ON-SITE SEWAGE DISPOSAL SYSTEM

PROPERTY ADDRESS: 18342 Chelsea Knolls Drive

RE: 18342 Chelsea Knolls Drive, BAT Plan comment

RE: 18342 Chelsea Knolls Drive, BAT Plan comment

FIGURE 4.1 CENTER FEED MANIFOLD DISTRIBUTION NETWORK

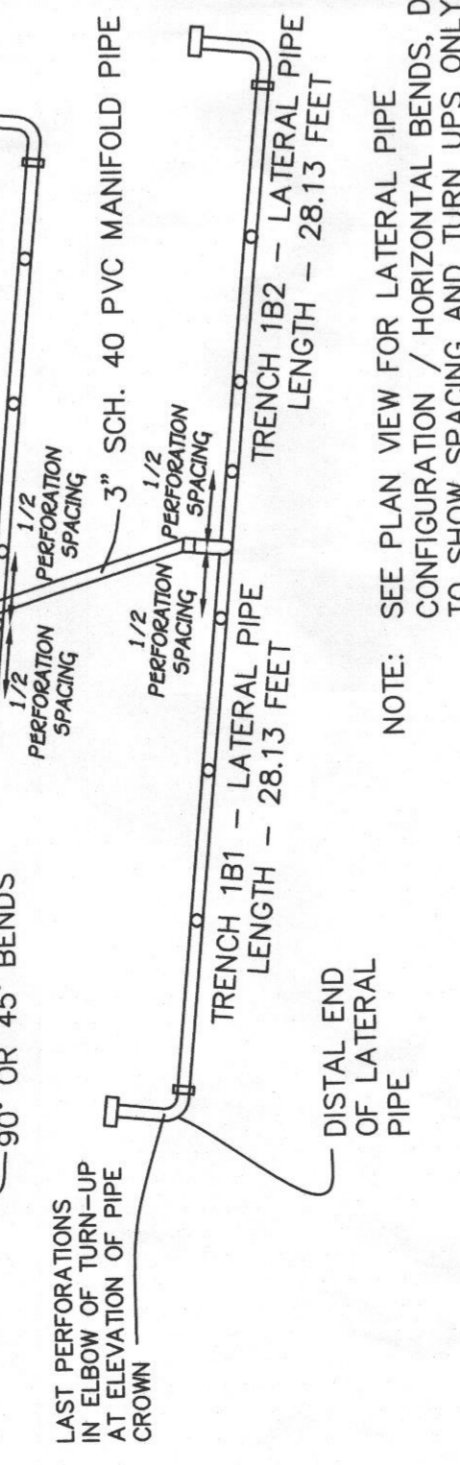
8. In diagram for CENTER FEED LAYOUT, label the 1/2" perforation spacing at the beginning of each lateral.
9. In PERFORATED PVC LATERAL PIPE BLOWUP DETAIL, increase the font size for the labels so that they are clearly legible.

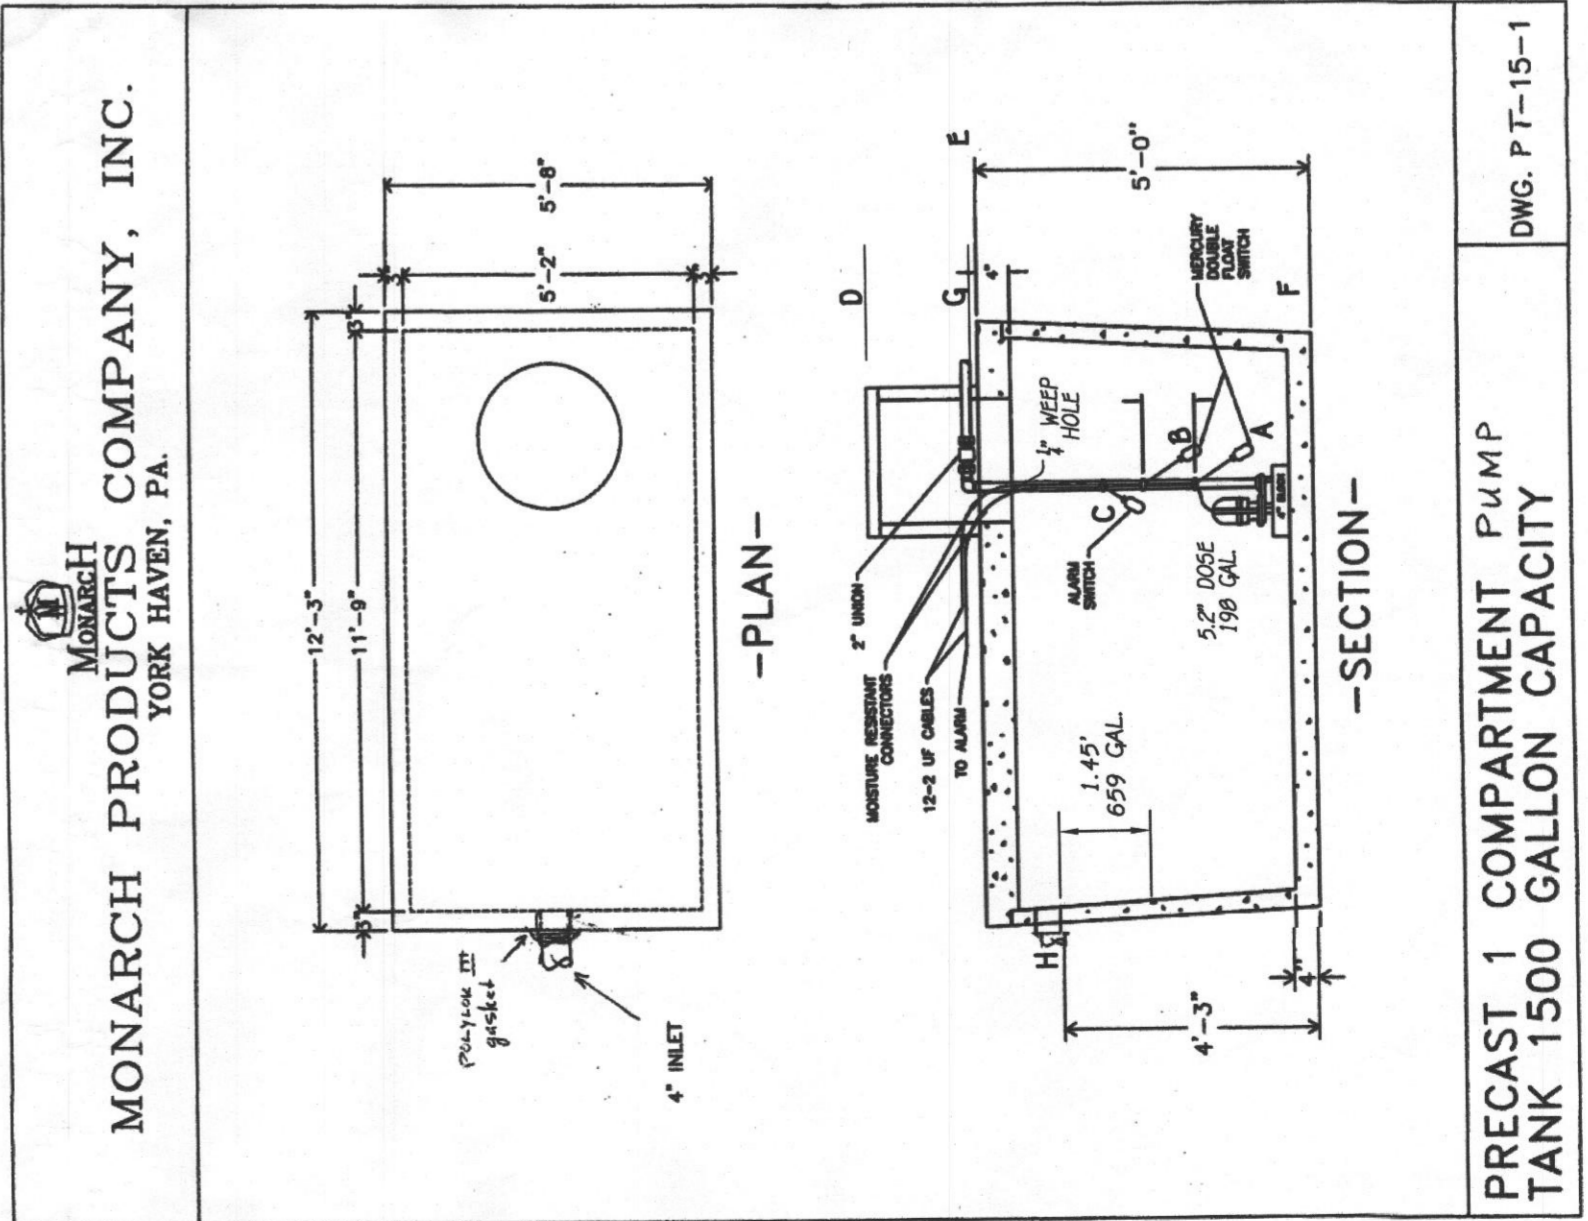
- c. Add a line under DYAMIC HEAD stating the APPROXIMATE DISTAL HEAD FOR (pump model, horsepower).
2. You illustrate in the Pump Tank design (on Sheet 2) a dose of approx. 147.5 gallons. Under MINIMUM DOSE on Sheet 1, you state that the dose will be 177 gallons. These values need to be reconciled.

3. Also, in the PUMP TANK DESIGN DETAIL, there are two (2) dose volumes illustrated. One value is in agreement with the values given for PUMP ON to PUMP OFF height, the other value is twice as much. Delete the volume that is not recommended for this proposed design.
4. Add a note in a prominent location near Plan View stating that "A Watertight Test IS REQUIRED FOR BOTH THE BAT TANK AND THE PUMP TANK." This is due to their proposed location.

PLAN VIEW
SCALE 1" = 30'

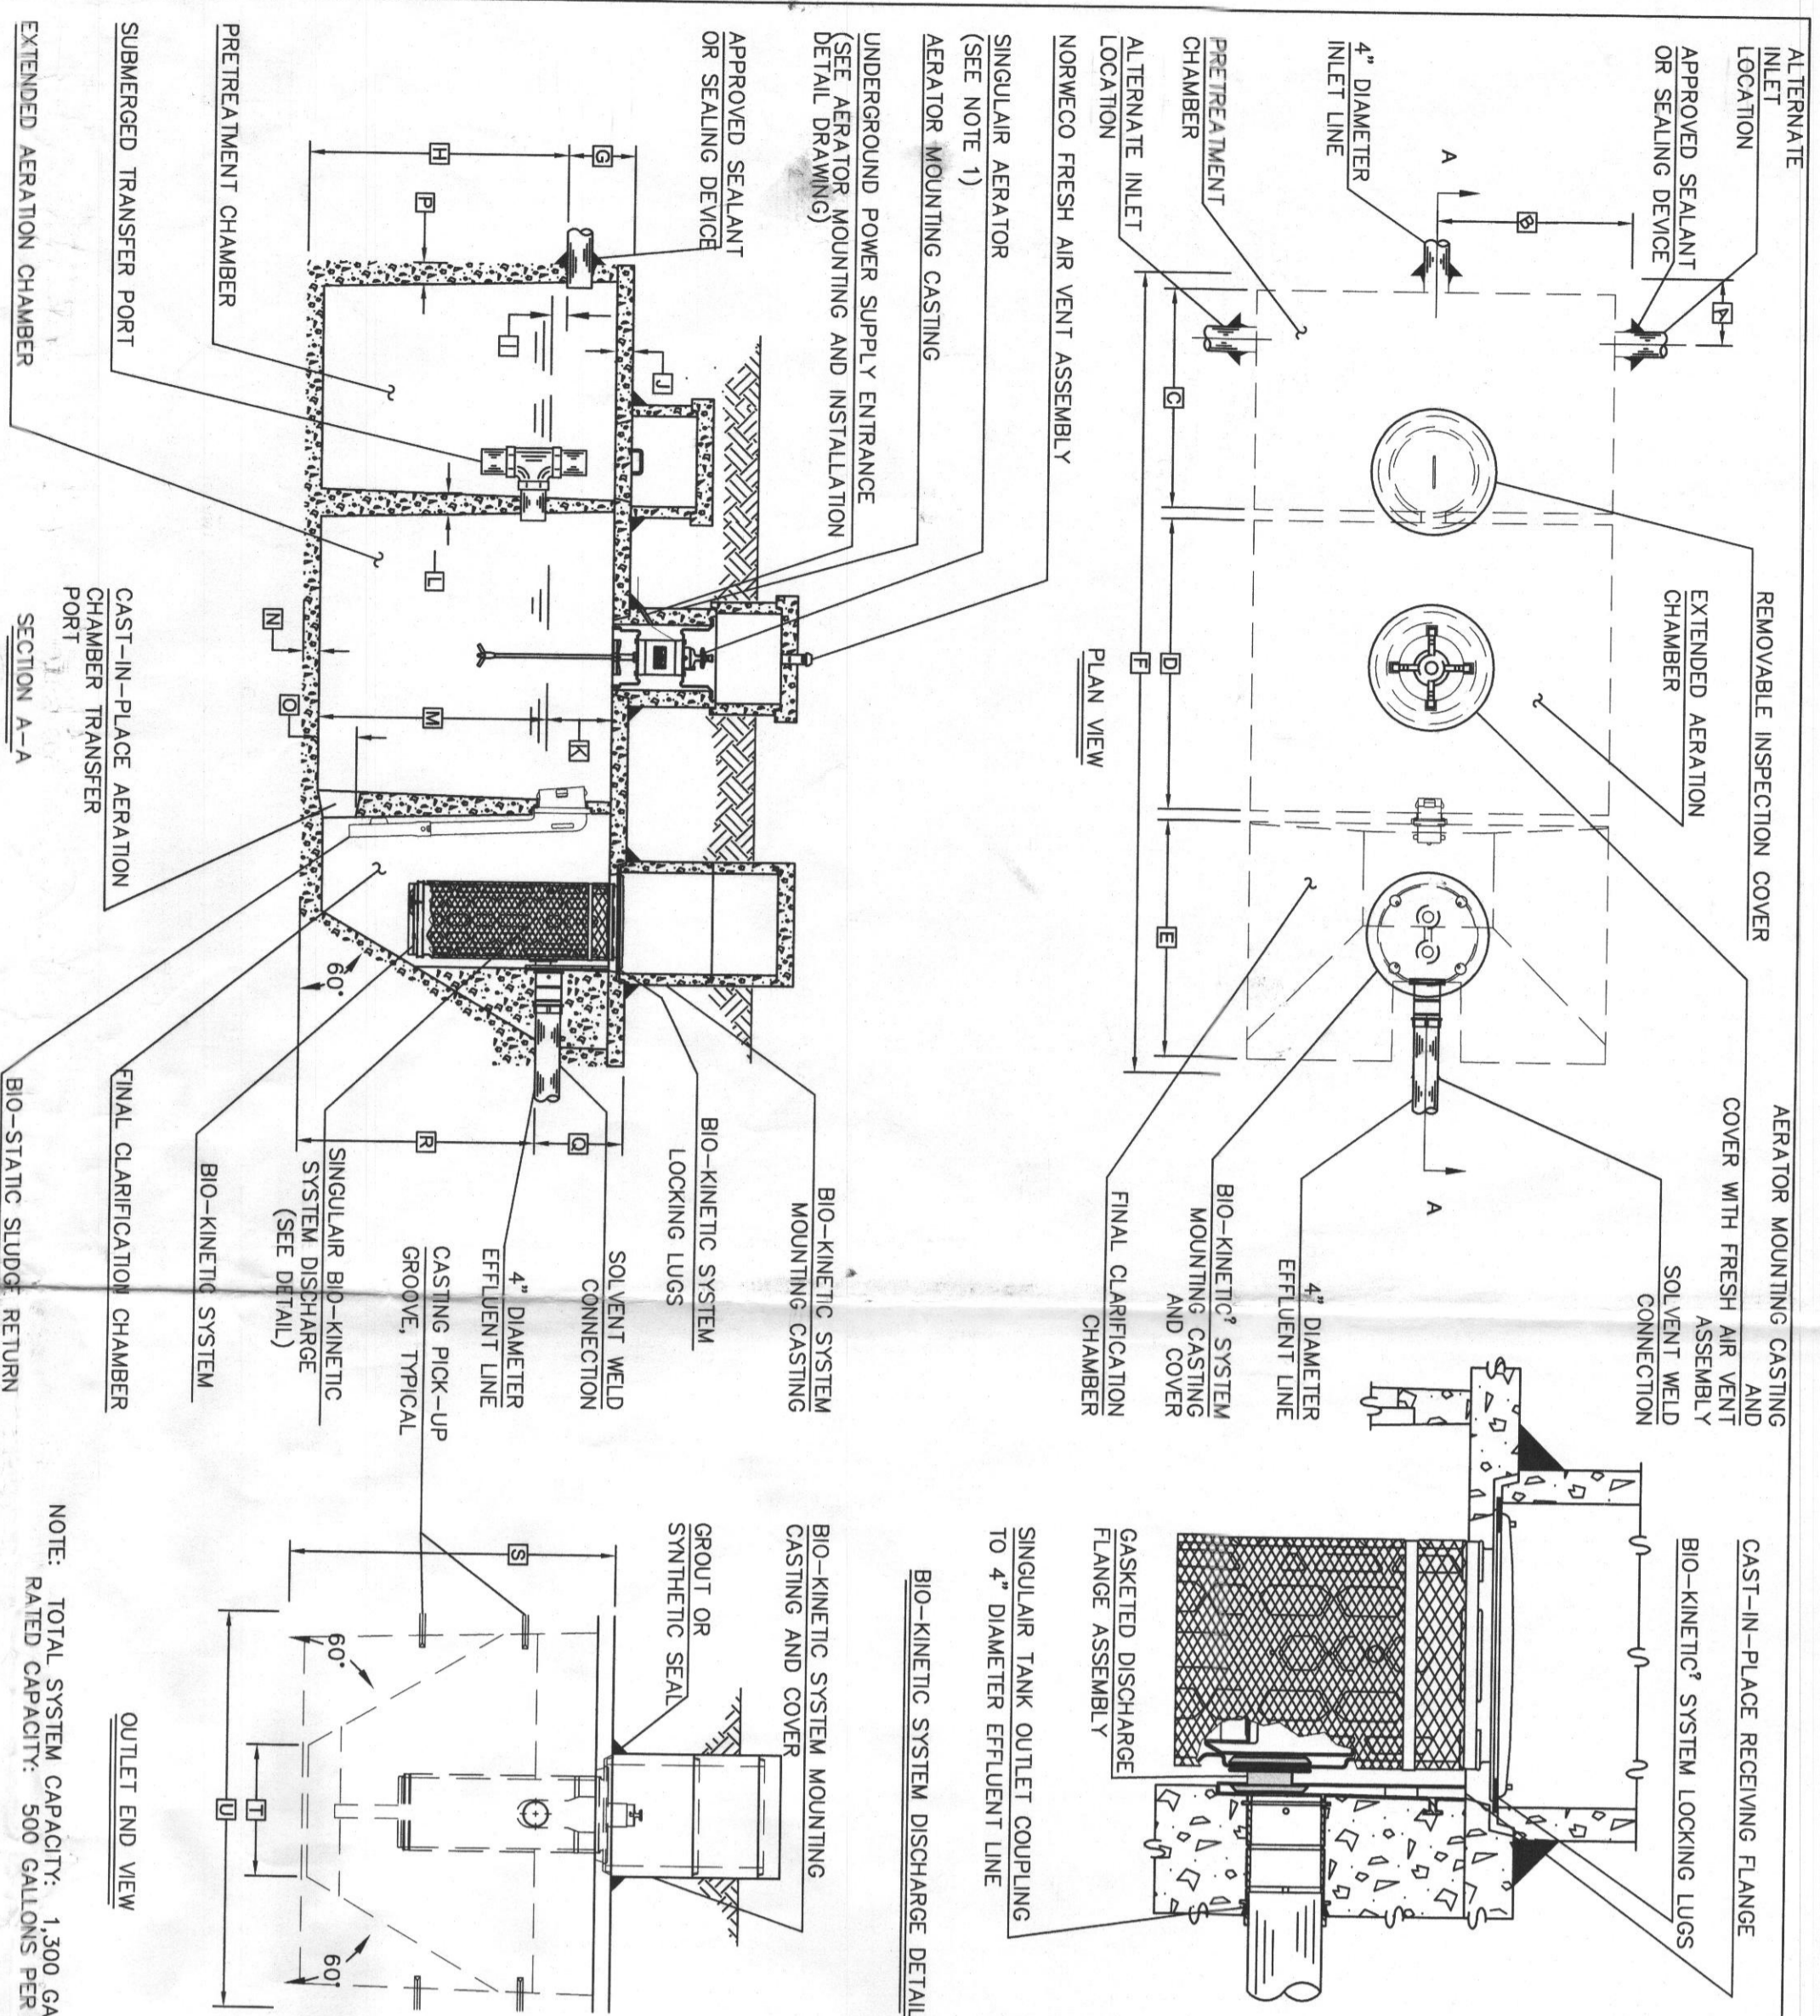
1. The trenches in the Plan View (Sheet 1) should be depicted as 60-ft trenches with the manifold located so as to bisect each trench at its centerpoint.
